TERRA JSP17-52

Public hearing at the request of Cambridge Homes, Inc for Planning Commission approval of a Woodlands Permit for Phase 1A. The subject property is currently zoned R-1 (One-Family Residential) with a Planned Rezoning Overlay Agreement. The subject property is approximately 30-acres and is located east of Napier Road and on the north side of Nine Mile Road (Section 29, 30). The applicant previously received approval of a 41-unit single-family housing development. The previous Woodland Permit granted in 2018 has expired.

Planning Review
TERRA (fka Villa D'Este)
JSP 17-52

RE: Terra – Third Revised Final Site Plan – Phase 1A
JSP 17-52 Terra

W-1

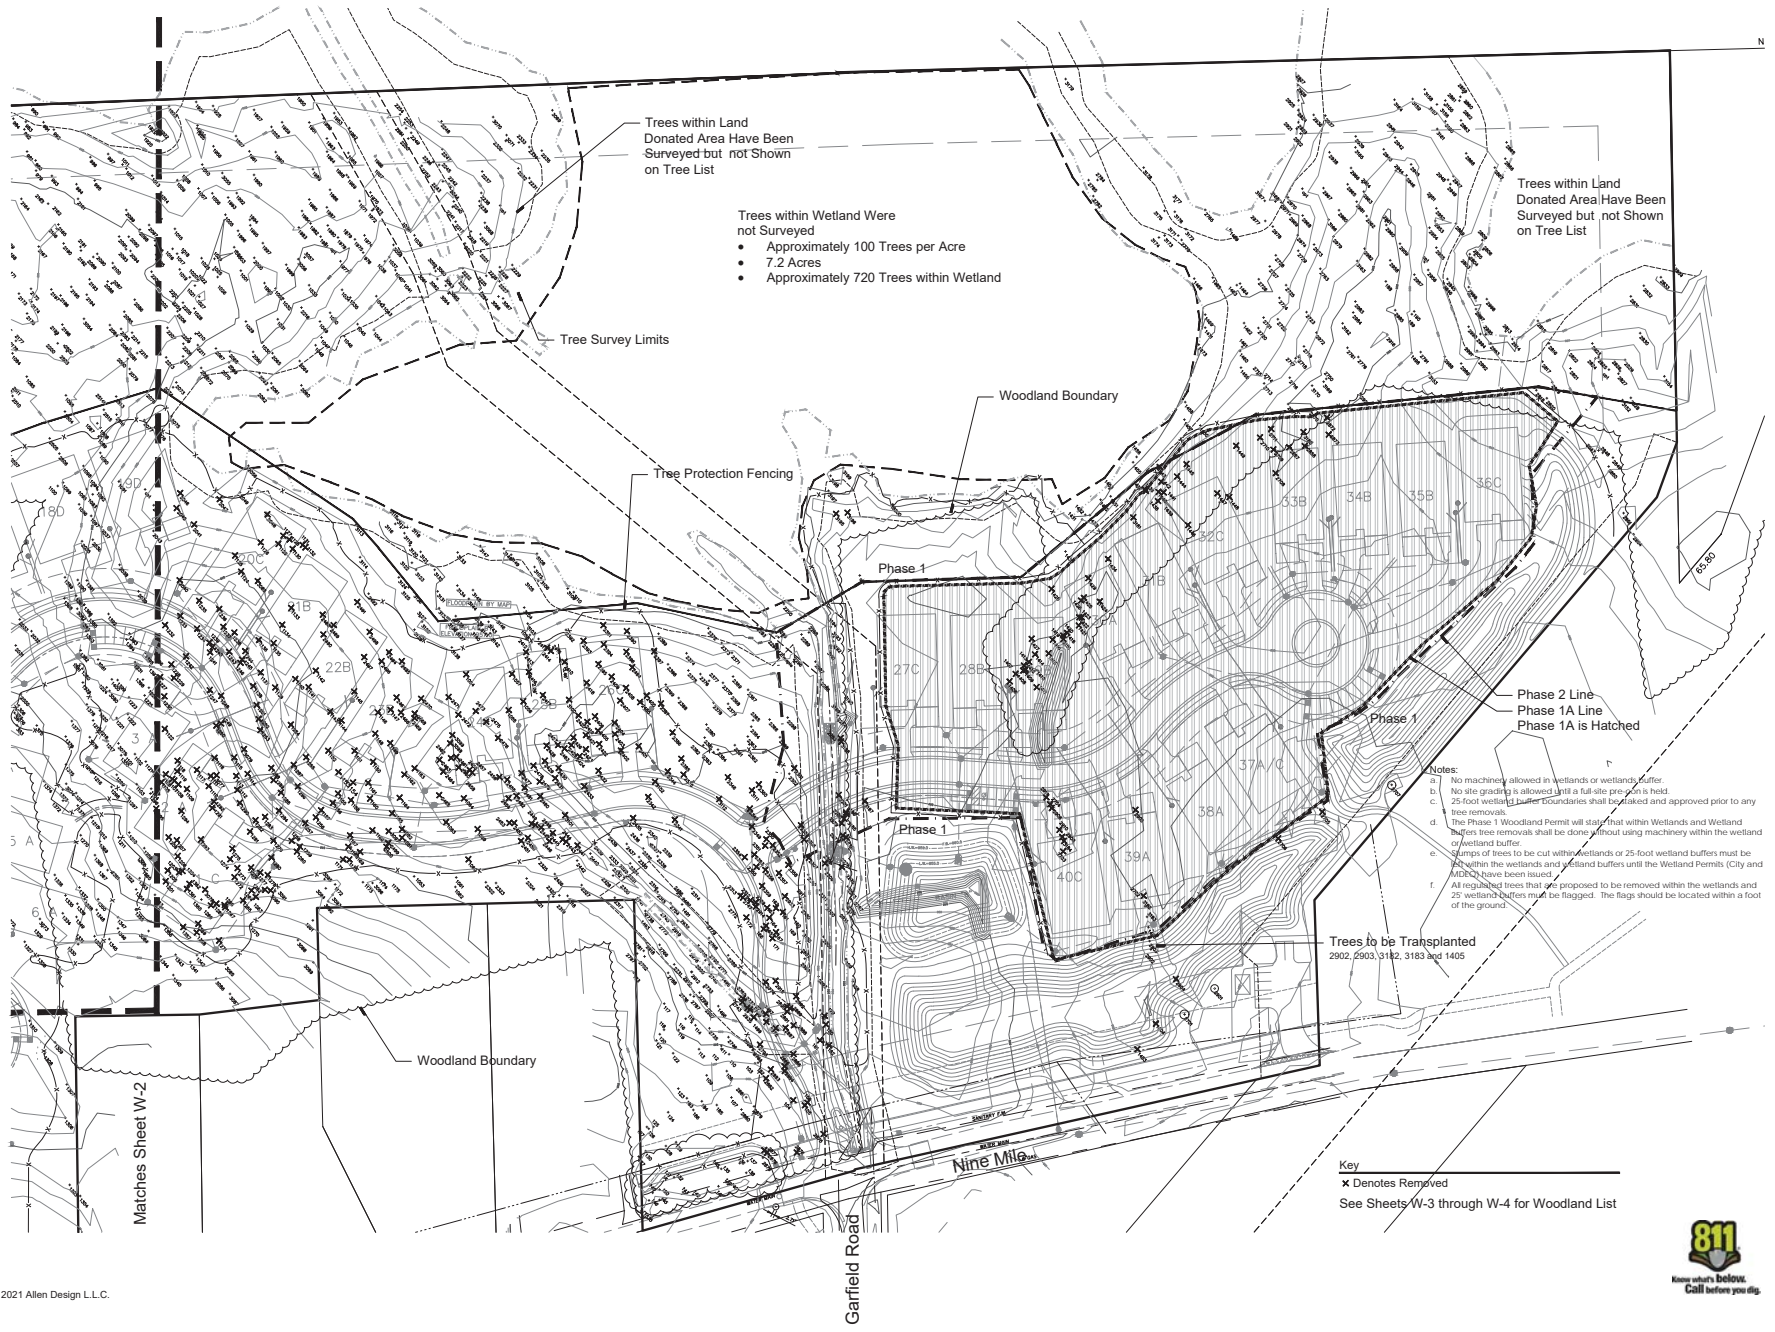
4. Revised Phasing Plan: The current submittal includes the addition of a new phase to the plan, labeled 1A. It appears the only work proposed within the 1A area would be the removal of 57 trees, as shown on sheet W-1 of the Plan set. No other work in the area designated Phase 2 would take place at this time. Staff has reviewed the revised Phasing Plan for woodlands only, as a part of the revised PRO Plan, and determined that the revised phasing may be approved administratively, and does not need to go through the full PRO amendment process. **The applicant shall include the PRO Site Plan in the Final Stamping Set to show the revised phase lines.**

1. On Sheet W-1, please add the tree list for Phase 1A, that includes tree tag #, species, size, condition, regulated/exempt, removed/preserved and required mitigation. Please see comments #2 and #3 for revisions required to the tree list.
2. Trees 1443 and 1429 are shown on Sheet W-1 as being removed, however, the tree list on Sheet W-4 has these trees listed as "Saved." Revise Sheet W-4 to reflect the tree removals and mitigation requirements.
3. To determine mitigation for multi-stem trees – the stems should be added together, divided by 8 and rounded up to the nearest whole number. The mitigation calculation for tree number 1426 is incorrectly calculated and should be 5 trees. Please revise sheet W-4.
4. The Landscape Plans do not show where the three White Pines (Tree Tag numbers 1405, 3182 and

3183) will be transplanted on the site. To be credited for preservation and mitigation the trees must remain on site. Clearly indicate where these trees will be transplanted on the site.

1. The mowing language will be added to the plans.
2. Trees #1405, #3182 and #3183 have been removed and will be replaced. Locations and species will be shown on a revised Landscape Plan.
3. Trees #2701, #2707 and #2901 have been removed and will be replaced. Locations and species will be shown on a revised landscape plan.
4. Phase 1 trees have been planted to the greatest extent possible. Phase 1A replacements will be planted as part of Phase 2 and will be planted once construction has been completed.

Figure 2. Terra Phase 1A (orange boundary and hatched)

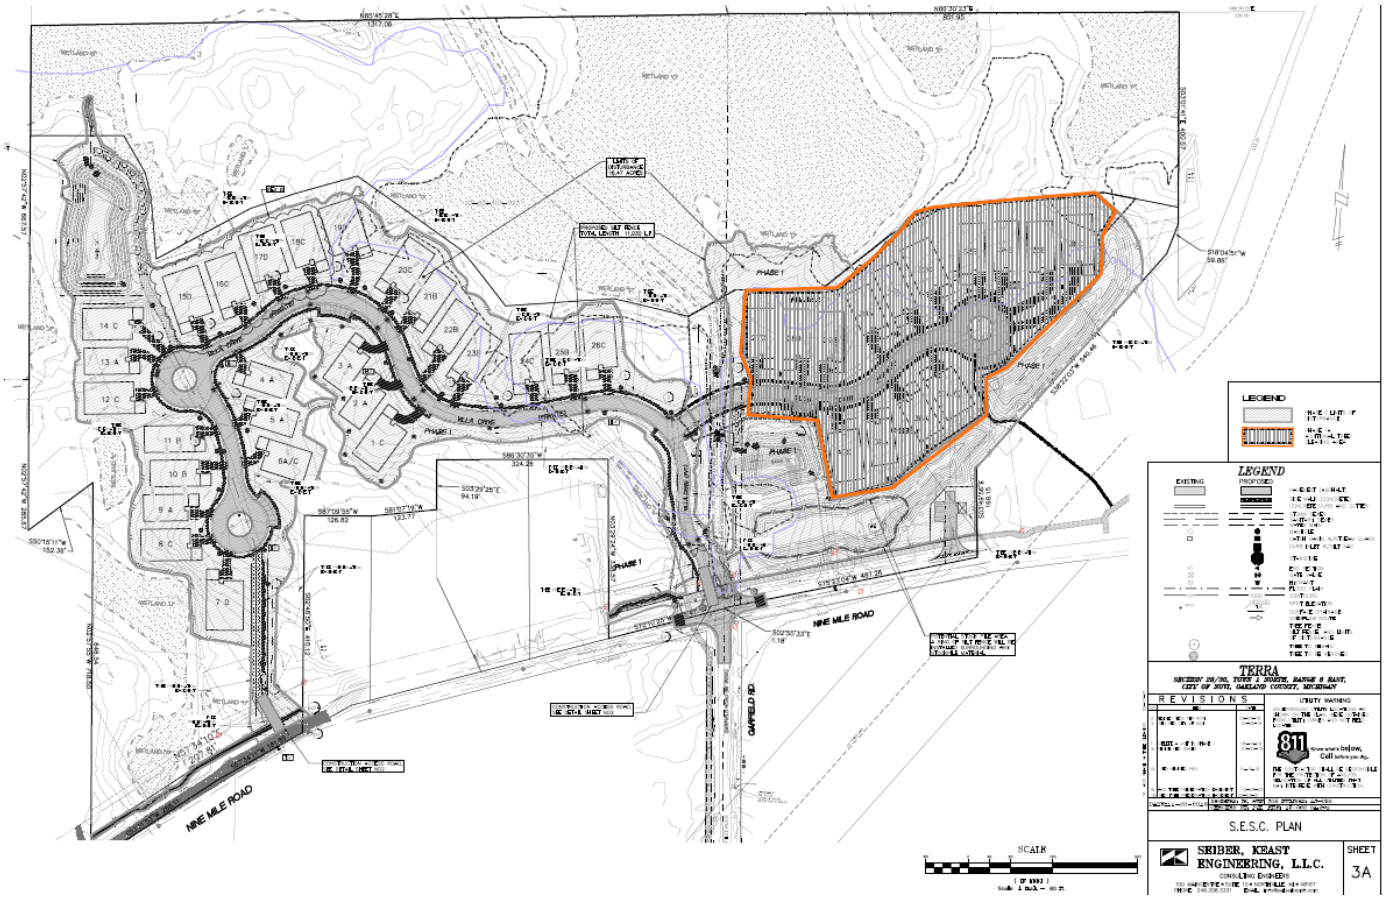
The applicant is proposing a Phase, 1A, to allow for the removal of regulated trees that were to be removed during Phase 2 as part of previously approved Preliminary and Final Site Plans (Figure 2).
